**SUBDIVISION,  
PLANNING APPROVAL,  
PLANNED UNIT DEVELOPMENT, &  
SIDEWALK WAIVER STAFF REPORT****Date: November 6, 2014**

<b><u>NAME</u></b>	Church of God Pentecostal
<b><u>SUBDIVISION NAME</u></b>	Mobile Terrace Subdivision, Lot 1 of Resubdivision of Lots 27, 28, 29 and 30, Block 17
<b><u>LOCATION</u></b>	345 Roosevelt Avenue (Northeast corner of Roosevelt Avenue and Eighth Street and Northwest corner of Roosevelt Avenue and Eight Street)
<b><u>CITY COUNCIL DISTRICT</u></b>	District 7
<b><u>PRESENT ZONING</u></b>	R-1, Single-Family Residential District
<b><u>AREA OF PROPERTY</u></b>	Subdivision: 1 lot / 0.2 ± acres PUD & PA: 2 lots / 0.5 ± acres
<b><u>CONTEMPLATED USE</u></b>	Planning Approval to allow the expansion of an existing church in a R-1, Single-Family Residential District, Planned Unit Development approval to allow shared parking between two separate lots and waive buffer fence requirements for an existing church school, Sidewalk Waiver approval to waive construction of a sidewalk along Roosevelt Avenue and Eighth Street and Subdivision approval to create one legal lot of record.

# DETAIL SITE PLAN

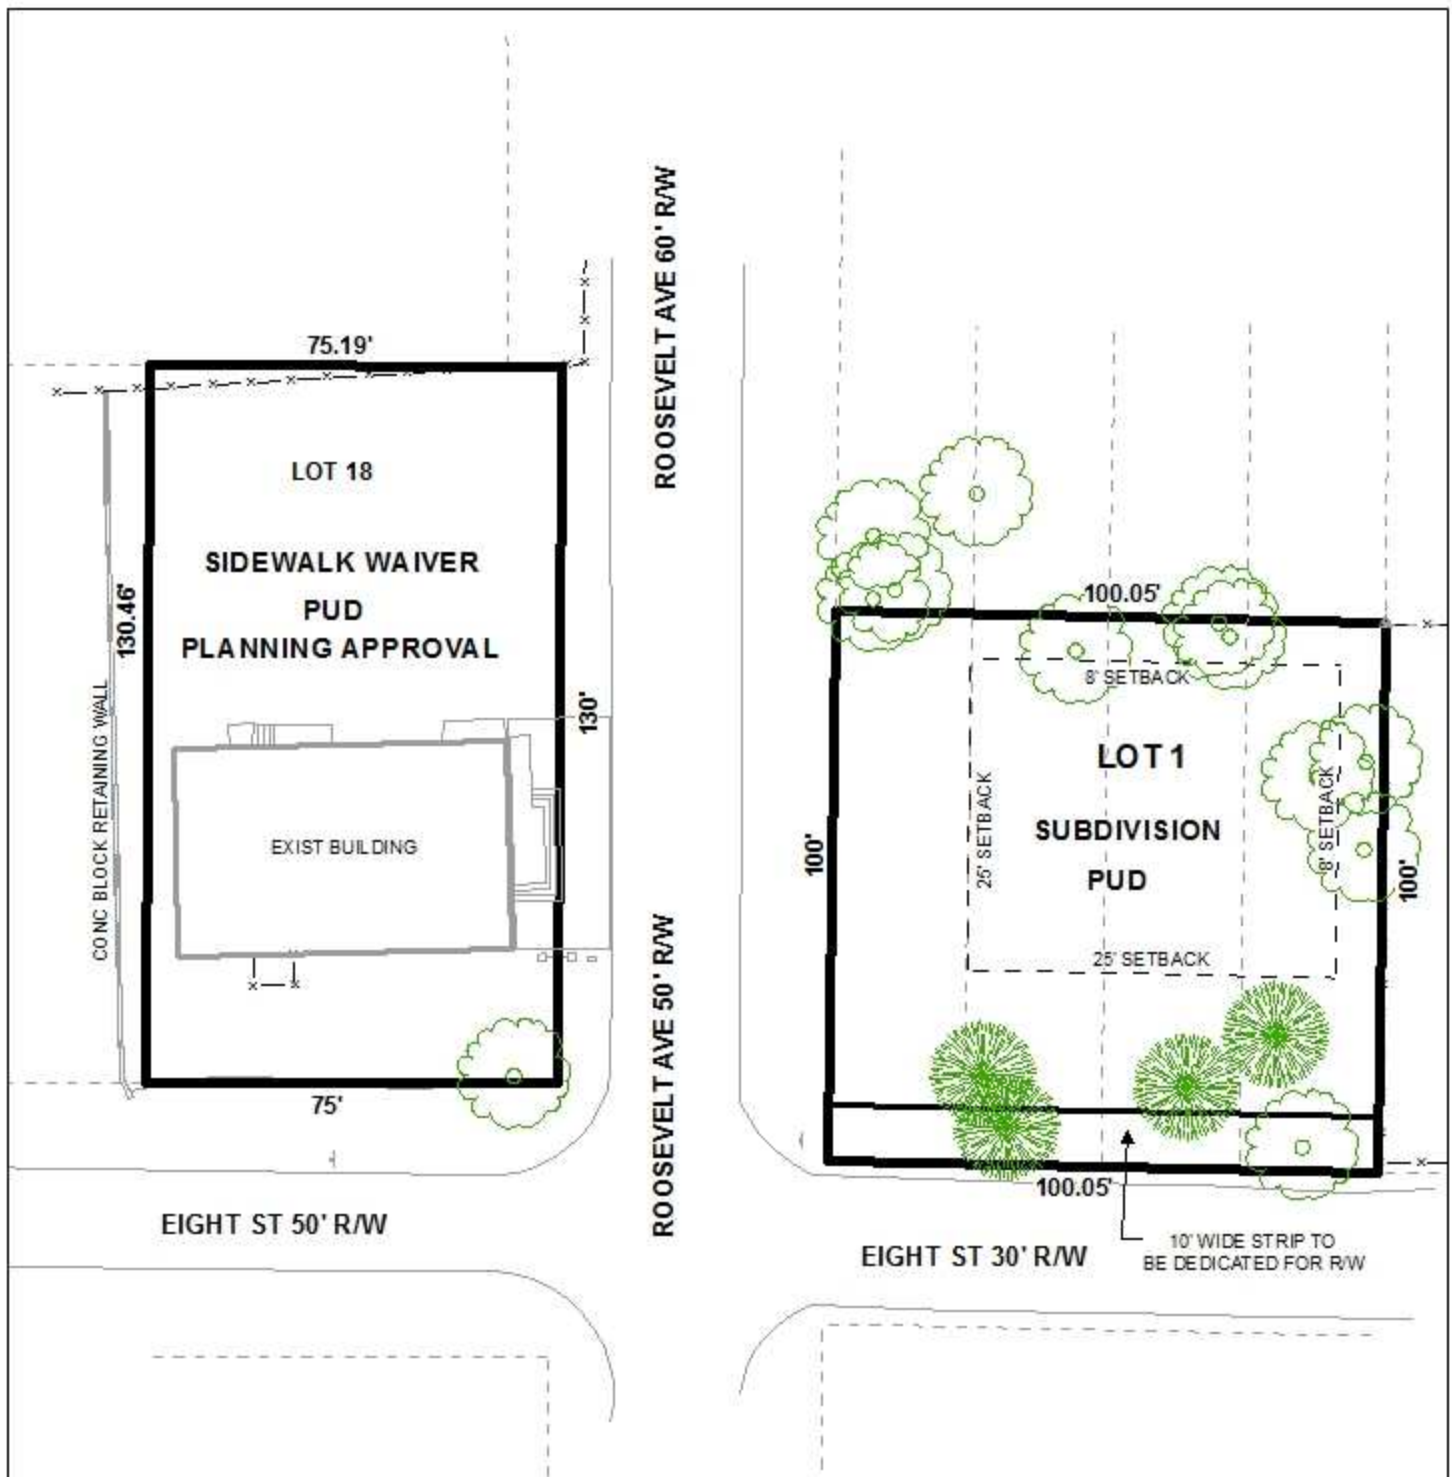
The site has frontage along two minor streets. Roosevelt Avenue has winged curbing but no gutter and Eighth Street has no curb-and-gutter adjacent to the site. The right-of-way width for Roosevelt Avenue is depicted as 50' and the right-of-way width for Eighth Street measures only 30' along the southern lot line of the proposed Lot 1; however, the applicant is proposing a 10' dedication to the City of Mobile to provide 25', as measured from centerline. The Subdivision Regulations requires a 60' right-of-way width for streets without curb-and-gutter; however, there do not appear to be any open drainage ditches in the immediate vicinity along either road and as the site is within an existing subdivision, only the provision of a corner radius in compliance with Section V.D.6. of the Subdivision Regulations should be required along the northeast corner of Roosevelt Avenue and Eighth Street. As such, a waiver of Section V.B.14. of the Subdivision Regulations will be required for approval since the applicant is proposing dedication sufficient to provide 25' as measured from centerline, instead of the required 30'.

Further, it appears that the current parking areas on the proposed lot and existing lot where the church is located would be considered non-conforming and as such, non-conforming documentation should be submitted to the Planning Division of the Urban Development Department, if approved. The site plan illustrates 1 proposed accessible parking space adjacent to the church; however, there is no curbing or bumper stop illustrated. If approved, the parking space should be constructed in compliance with Section 64-6. of the Zoning Ordinance.

In accordance with the Subdivision Regulations, the proposed lot exceeds the minimum lot size requirements and the 25' minimum building setback line is depicted, but should be revised to reflect dedication of a corner radius at the northeast corner Roosevelt Avenue and Eighth Street, if approved.

It should be pointed out that the applicant has requested a waiver of the residential adjacency buffer requirements in Section 64-4.D.1. of the Zoning Ordinance. The Commission has considered such requests before, however, they have typically been based upon an adjacent homeowner requesting the omission of the buffer. When the Commission has approved such a request, it has typically been conditioned upon the buffer requirement be provided if, at anytime, an adjacent property owner (existing or future) requests such. If written requests are submitted by abutting property owners, the Commission should consider them; if, however, the request is only by the applicant, the Commission should be mindful of the requirement of buffering adjacent residential uses from more intense non-residential uses.

If a buffer will be provided, notes should also be placed on the revised site plan stating that any proposed privacy fencing is not to exceed 3' in height within the 25' minimum building setbacks of Roosevelt Avenue and Eighth Street.

No dumpster is depicted on the site plan; however, a note is listed stating that garbage will be via curb-site pick up. If approved, these notes should be retained on any revised site plan.

The site plan also depicts a proposed detention area on the south side of the existing church. The proposed detention area will require proper land disturbance permitting.

- 1) Revision of the site plan to depict the provision of a corner radius at the northeast corner of Roosevelt Avenue and Eighth Street, in compliance with Section 64-4.D.1. of the Zoning Ordinance;

- 2) Revision of the 25' minimum building setback line on the revised site plan to reflect dedication;
- 3) Illustration of a bumper stop or curbing for proposed parking space;

- 4) Illustration of a residential buffer along all property lines adjacent to residentially used property or the submission of requests from adjacent property owners requesting that the buffer requirement be waived until requested at a future date;

- 5) Placement of a note on the site plan stating that any proposed privacy fencing provided as a buffer is not to exceed 3' in height within the 25' minimum building setbacks of Roosevelt Avenue and Eighth Street;

- 6) Retention of dumpster notes on the revised site plan;
- 7) Compliance with Engineering comments: *(ADD THE FOLLOWING NOTES TO THE PUD SITE PLAN: 1. Any work performed in the existing ROW (right-of-way) such as driveways, sidewalks, utility connections, grading, drainage, irrigation, or landscaping will require a ROW permit from the City of Mobile Engineering Department (208-6070) and must comply with the City of Mobile Right-of-Way Construction and Administration Ordinance (Mobile City Code, Chapter 57, Article VIII). 2. A Land Disturbance Permit application shall be submitted for any proposed land disturbing activity with the property. A complete set of construction plans including, but not limited to, drainage, utilities, grading, storm water detention systems, paving, and all above ground structures, will need to be included with the Land Disturbance permit. This Permit must be submitted, approved, and issued prior to beginning any of the construction work. 3. Any and all proposed land disturbing activity within the property will need to be submitted for review and be in conformance with Mobile City Code, Chapter 17, Storm Water Management and Flood Control; the City of Mobile, Alabama Flood Plain Management Plan (1984); and, the Rules For Erosion and Sedimentation Control and Storm Water Runoff Control.);*
